Village of Arlington Heights
Plan Commission
Board Room
Arlington Heights Village Hall
33 S. Arlington Heights Road
Arlington Heights, IL 60005
July 25, 2018
7:30 PM

- A. Napleton/Arlington Lanes Parking Lot - 3435 N. Kennicott Ave. -
PC#18-014
Land Use Variation for Auto Sales Lot, Variations
- B. Arlington Downs - 3400 W. Euclid Ave. - PC#18-010
PUD Amendment, Plat of Subdivision, Amendment to SUP,
Land Use Variation, Variations

REPORT OF THE PROCEEDINGS OF A PUBLIC HEARING
 BEFORE THE VILLAGE OF ARLINGTON HEIGHTS
 PLAN COMMISSION

RE: EUROPEAN CRYSTAL HOTEL - 519 WEST ALGONQUIN ROAD - PC#18-013
 LAND USE VARIATION FOR HOTEL, VARIATION FROM CHAPTER 28 OF THE
 MUNICIPAL CODE

Sheet No:
C-2.01

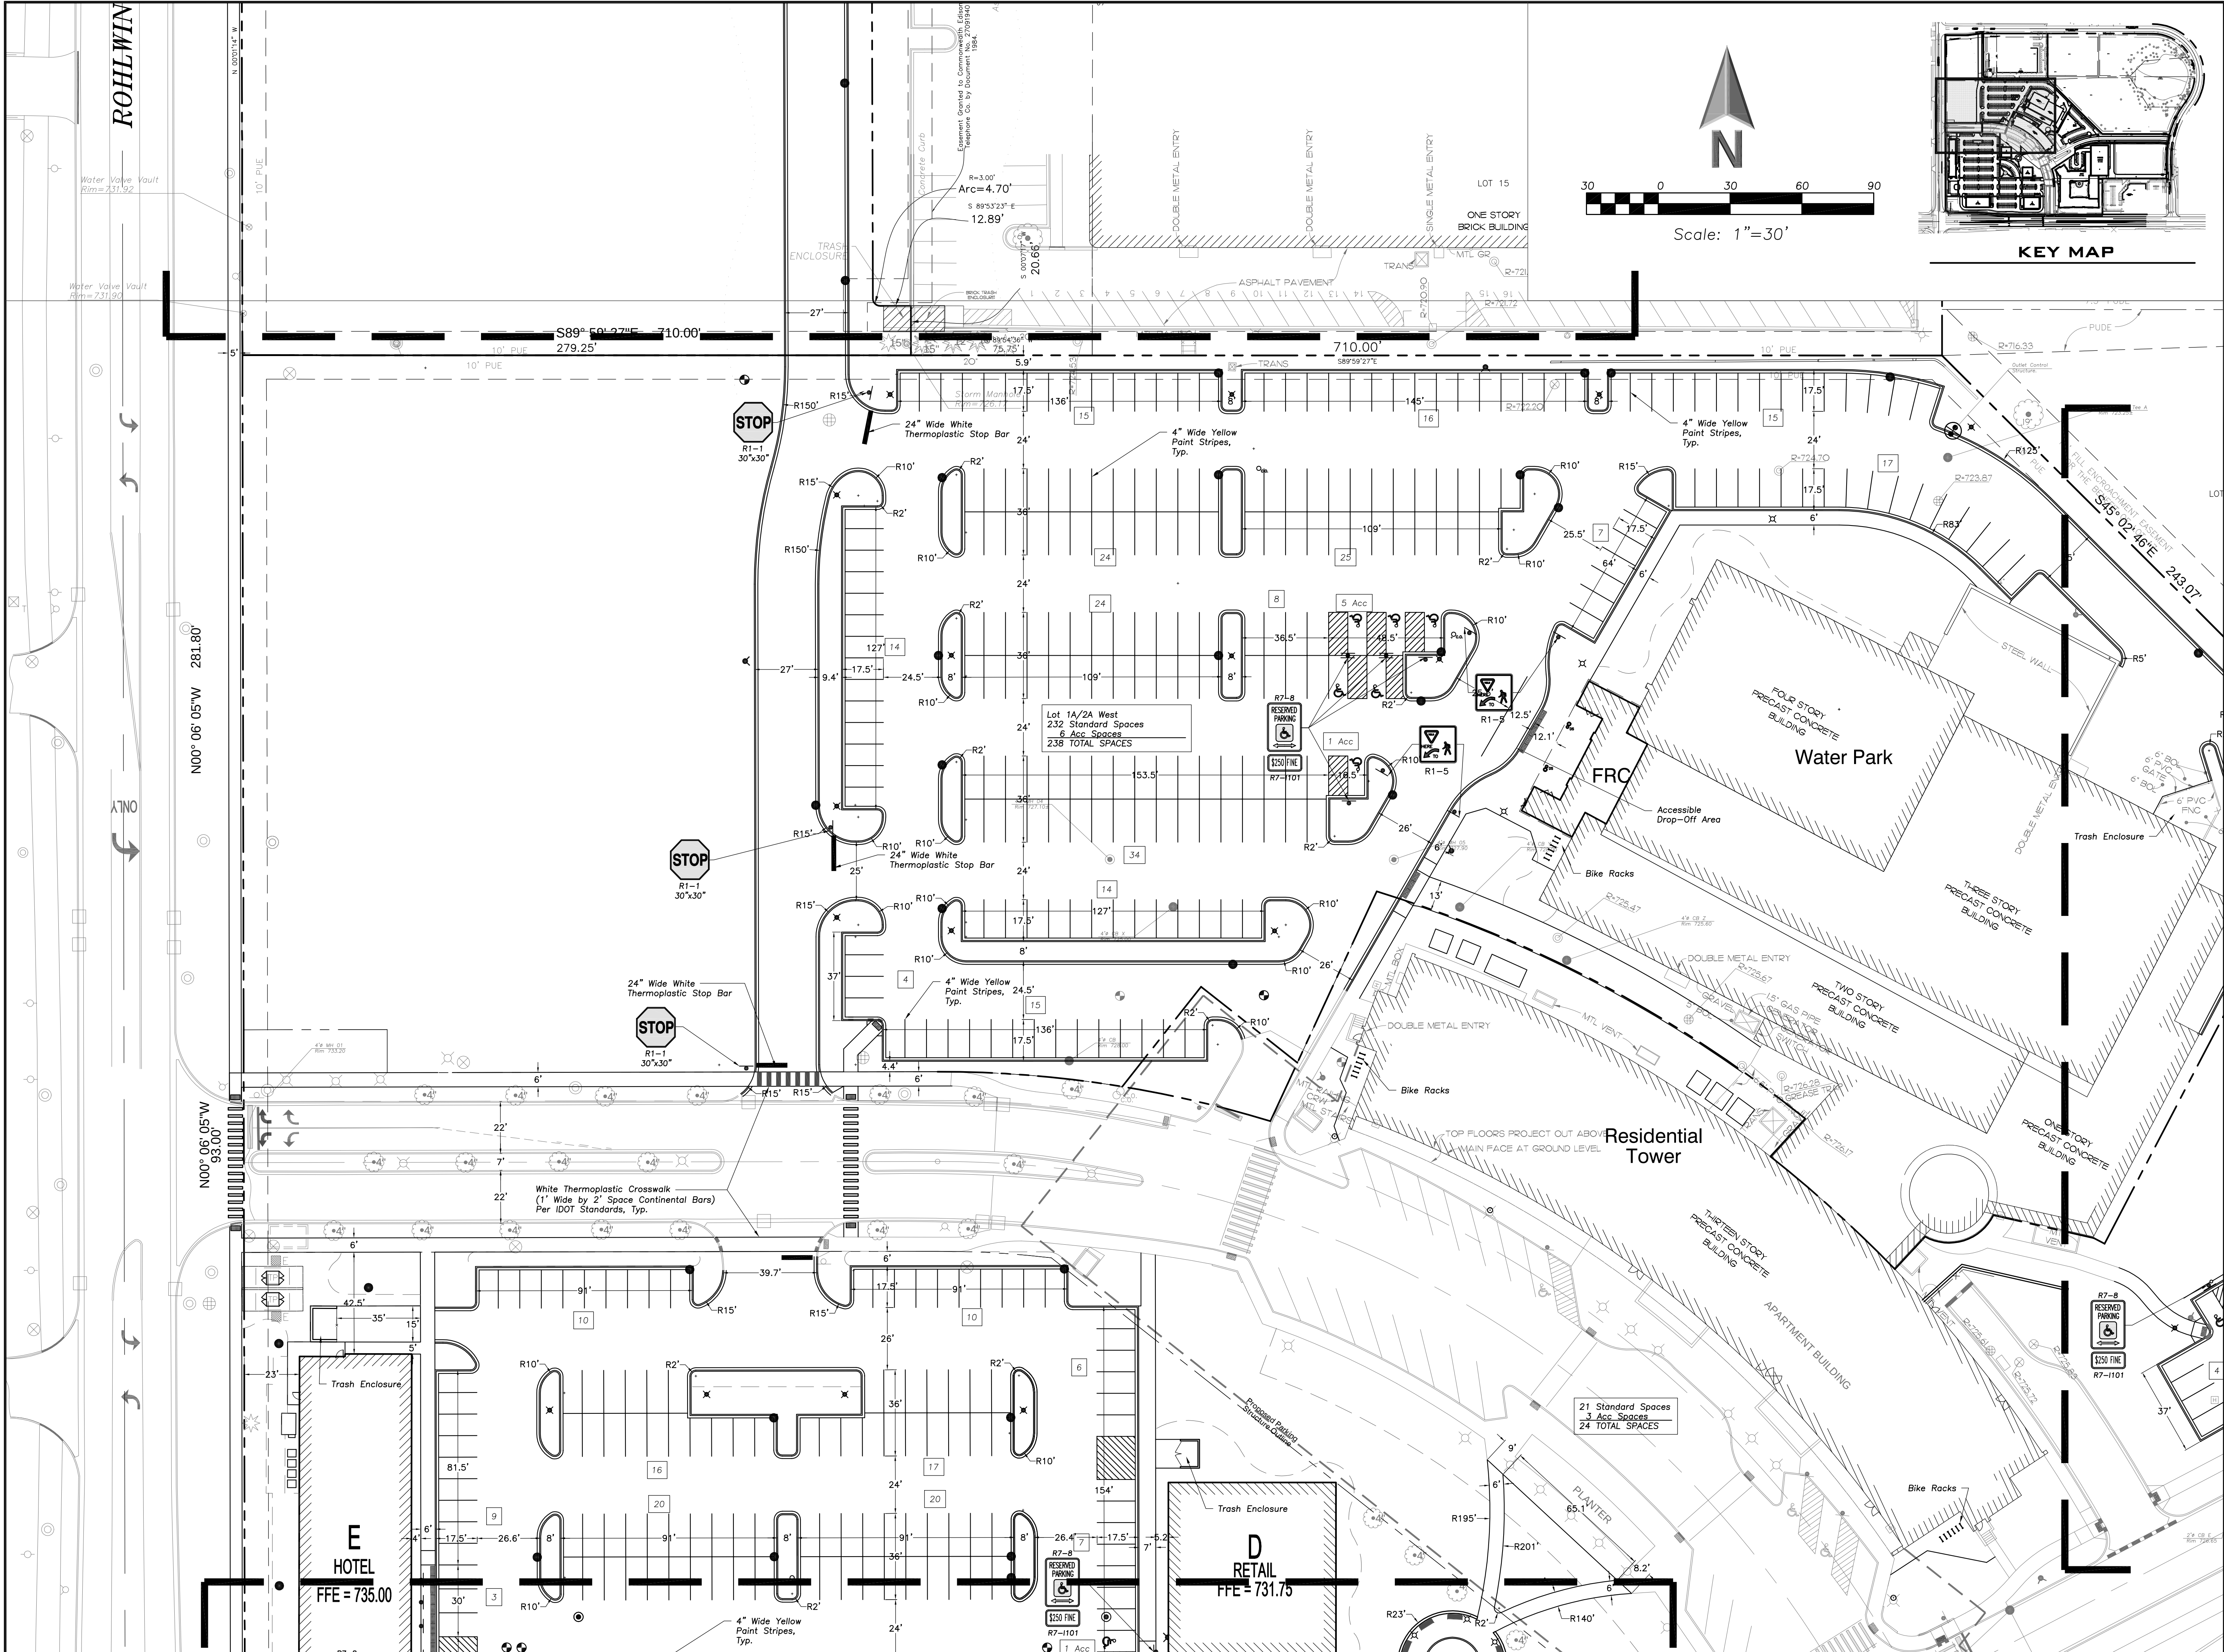
37. Sheet C-2.01: Sidewalk shall go through the driveway at Salt Creek Lane. Curb to stop on either side. Same comment for Sheet C-2.05.
38. Sheet C-5.01: The improvements to southbound Rohlwing Avenue at Euclid Avenue are shown on this plan sheet, but are not shown on any of the other plan sheets. Is this work to be included anywhere in this project, and what is the anticipated timeline?

Date 4/07/18	Project No. DWP 18-120
Scale 1" = 30'-0"	Sheet No. L-2.2
Drawn By FERGUSON	
Approved

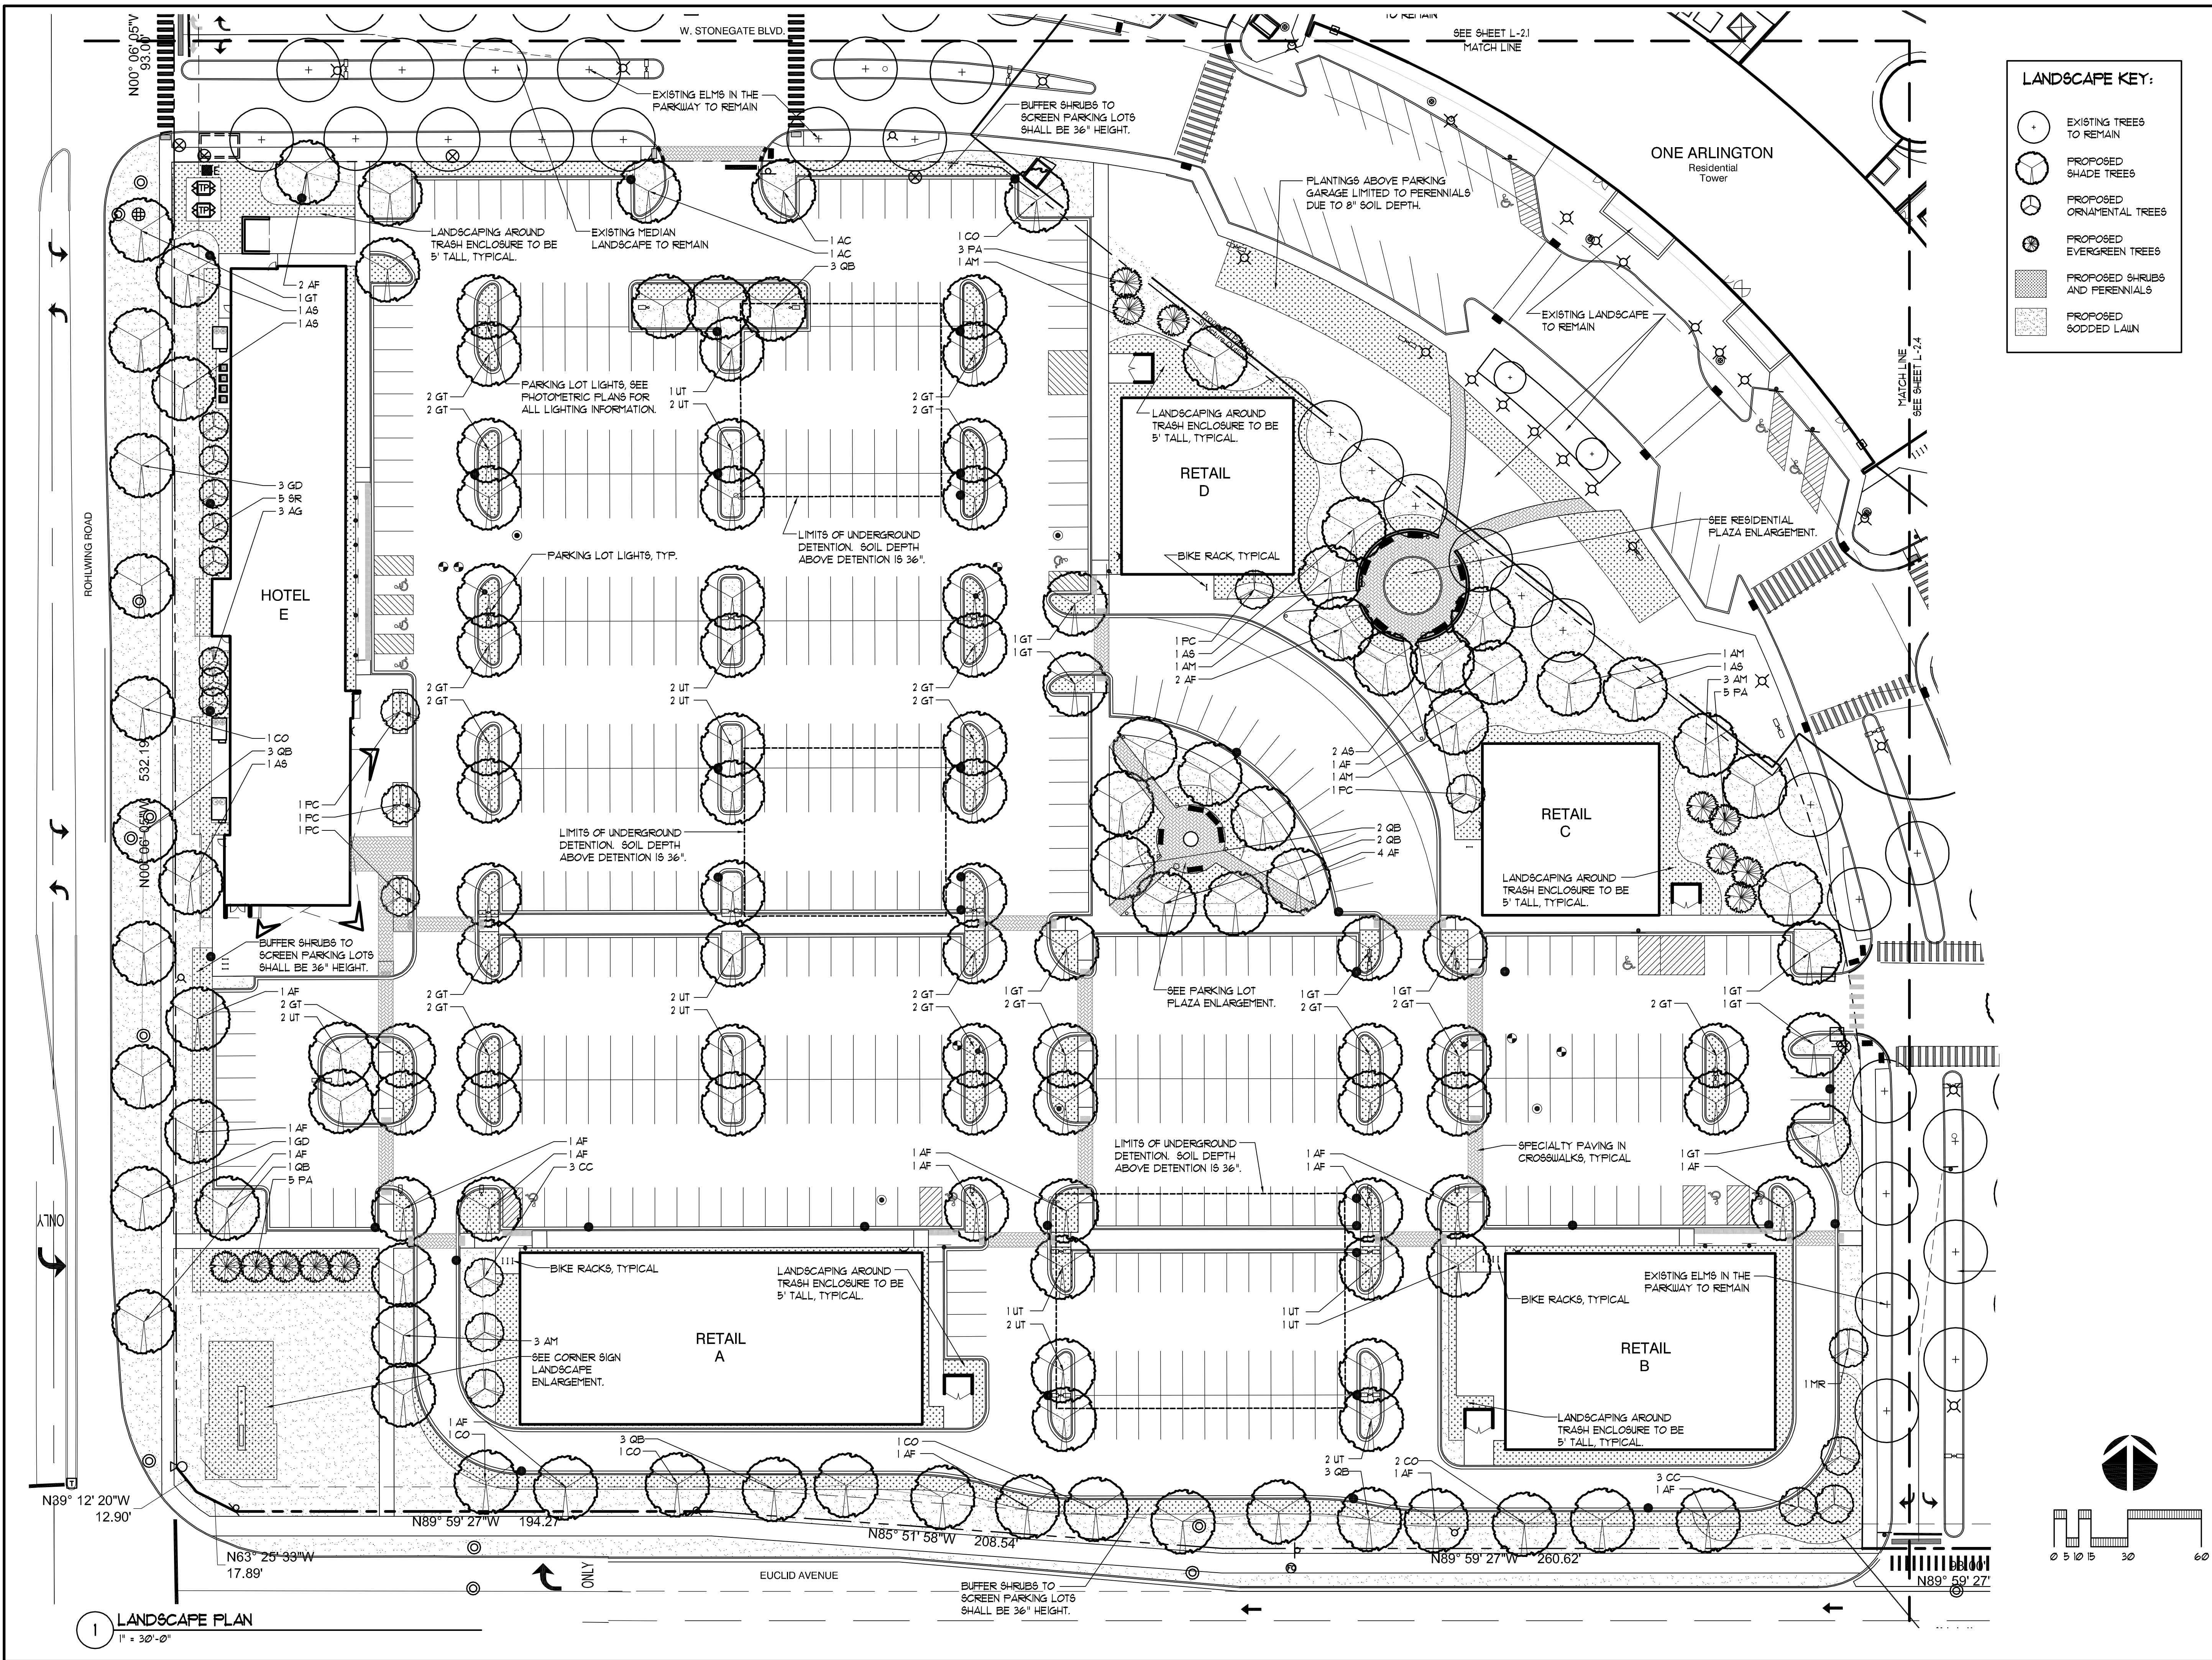
26. What is the cross-hatched feature on sheet L-2.2 on the landscape plan?

26. What is the cross-hatched feature on sheet L-2.2 on the landscape plan?
